# UNITED STATES PATENT AND TRADEMARK OFFICE

APPLICATION NO.	FILING DATE	FIRST NAMED INVENTOR	ATTORNEY DOCKET NO.	CONFIRMATION NO.
10/005,000	12/07/2001	James H. Lee	H-204145	1829

# Office Action Summary

### DETAILED ACTION

FIG. 1

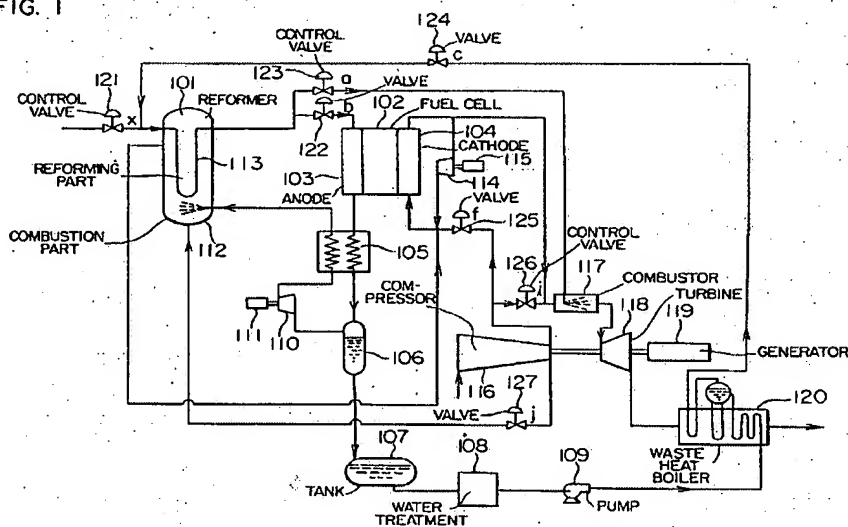
Sugita et al disclose a fuel cell system wherein fuel is used directly as a heating medium for raising the temperature of the system (ABSTRACT). **Figure 1** below shows the fuel cell system comprising a pump 109 which is connected to the waste heat boiler 120 which transfer heat to the water to create steam wherein the heat waster boiler 120 is further connected to the inlet part of the reformer 101 (COL 3, lines 34-42). The fuel cell system comprises the fuel cell 102; the air compressor 116, the turbine 118, the heat boiler 120 (COL 2, lines 53-57).

It is also evident from **Figure 1** that the fuel cell is connected to an expander (turbine 118), thereby delivering the exhaust to the expander. The compressor 116, the turbine 118 and generator 119 are connected with the same power system which is further connected through a clutch with a drive assembly to deliver work (COL 3, lines 14-22). Figure 1 also depicts that the expander is connected to another fuel cell component to use the generated work.

**Figure 1** also illustrates that the expander (turbine 118) is in flow communication (connected) with fuel cell through the reformer 101 wherein the fuel cell anode outlet is

connected to the heat exchanger 105 and the outlet of heat exchanger is connected to the drum 106 (COL 3, lines 1-11) where they cool the anode outlet exhaust (COL 5, lines 1-10). Thus, both the heat exchanger 105 and the drum 106 act as a condenser by recovering constituent of the anode gas exhaust. Thereafter, the separated water enters water tank 107, then brought to elevated pressure and sent to the waste heat boiler 102 by means of the feed water pump 109 (COL 5, lines 55-62).
